KENDALL COUNTY
PLANNING, BUILDING & ZONING COMMITTEE MEETING

AGENDA

1. **Petition 24 – 30 – Nicholas S. Bellone on Behalf of Ament Solar 1, LLC (Tenant) and Janet M. Dhuse on Behalf of the Janet Dhuse Declaration of Family Trust Dated March 1, 2013 (Owner) (Pages 13-954)**

Request: Special Use Permit for a Commercial Solar Energy Facility and Variance to Section 36-282(17)(a) of the Kendall County Code to Allow a Commercial Solar Energy Facility on Land within One Point Five (1.5) Miles of Municipality without an Annexation Agreement
PINs: 05-16-300-006 and 05-17-400-005
Location: South of 9949 and 10021 Ament Road, Yorkville in Kendall Township
Purpose: Petitioner Would Like to Install a Commercial Solar Energy Facility; Property is Zoned A-1

C-2.0
LAYOUT AND MATERIALS PLAN

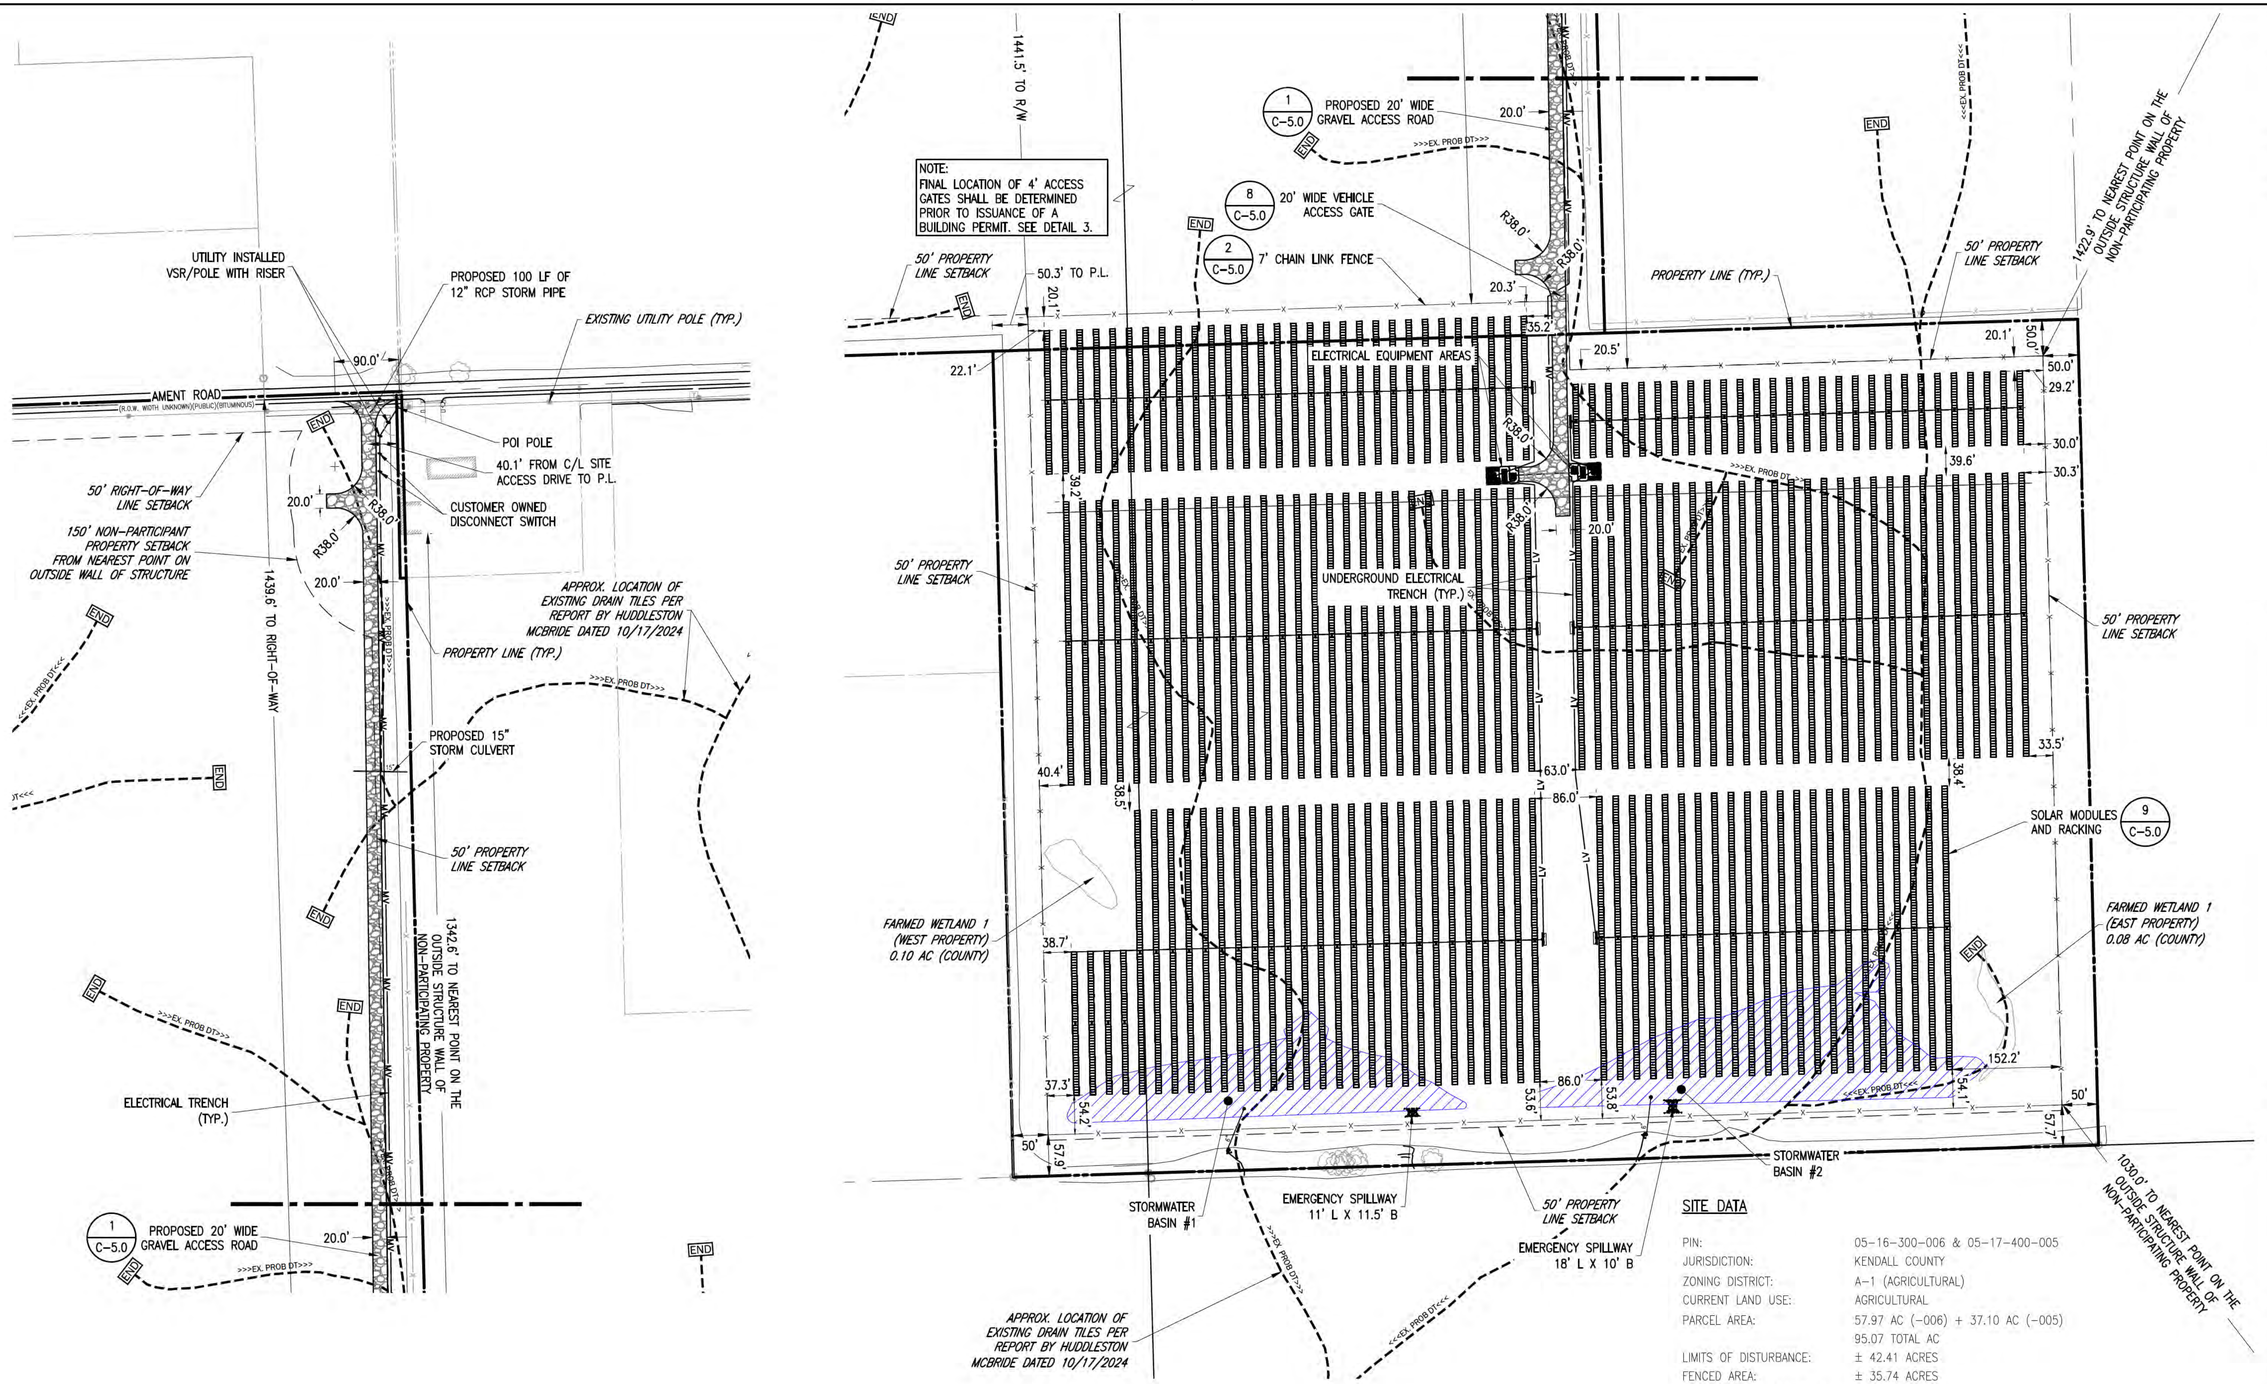
1. Pitch the gravel access road to the west and away from adjacent land at a 2% cross slope. As determined necessary, construct a low flow drainage pipe from the low point in DA #1 daylighting south to DA #3. Alternatively, raising the access road profile with a relatively flat overland drainage swale along the west side of the access road appears feasible.
2. Identify the entity for post-construction maintenance. The entity responsible for maintenance appears to be mentioned for erosion control but not post-construction maintenance. (Sheet C-5.1).
3. Please depict drain tiles on final engineering plans and provide a drain tile repair detail on the plan sheets.

C-3.0
GRADING AND EROSION CONTROL PLAN

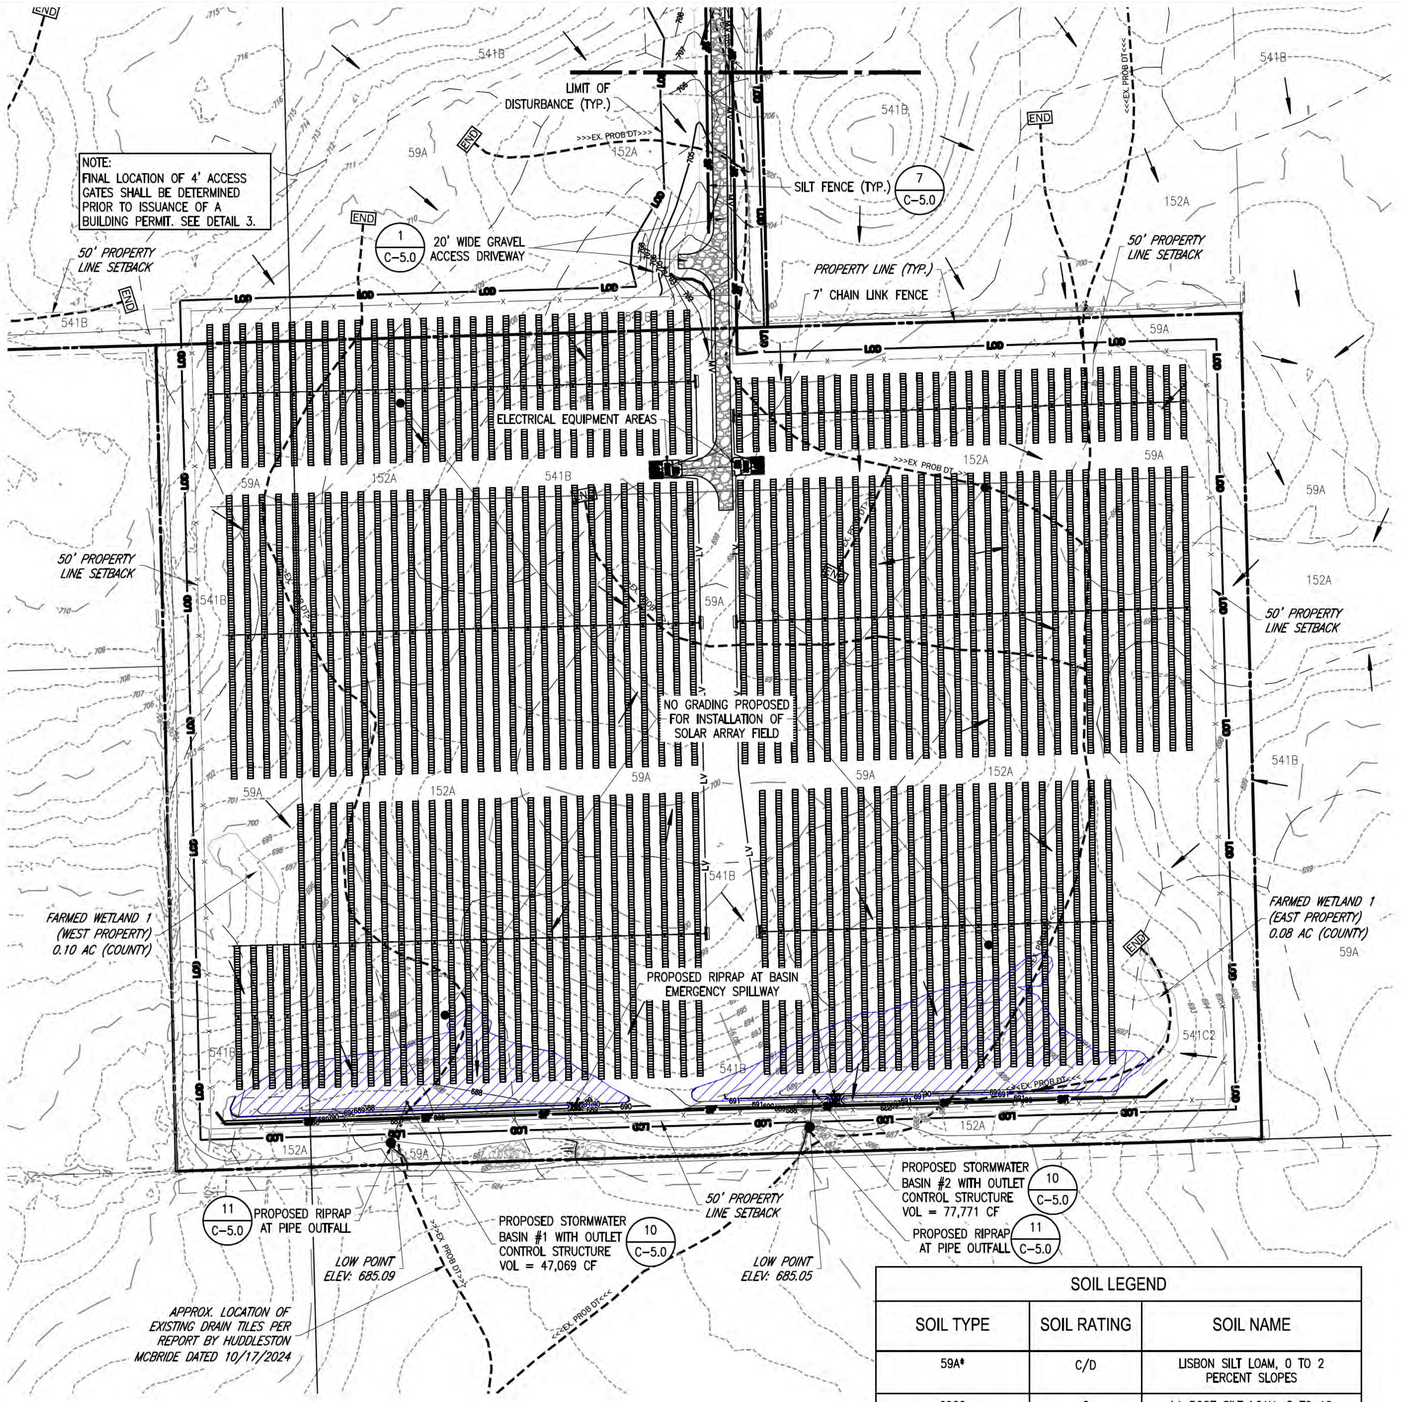
2. Sheet C-3.0: Please include drainage pattern arrows and locations of site outfalls. It is noted that these will be existing drainage patterns to be maintained.
    - **NLE Response: These have been added to Sheet C-3.0.**

4. Sheet C-3.0: The concrete washout basin appears to be located outside of the silt fence. Please relocate or confirm in the call out that the concrete washout basin shall be located within the silt fence.
    - **NLE Response: The limits of the silt fence has be relocated around the concrete washout basin.**
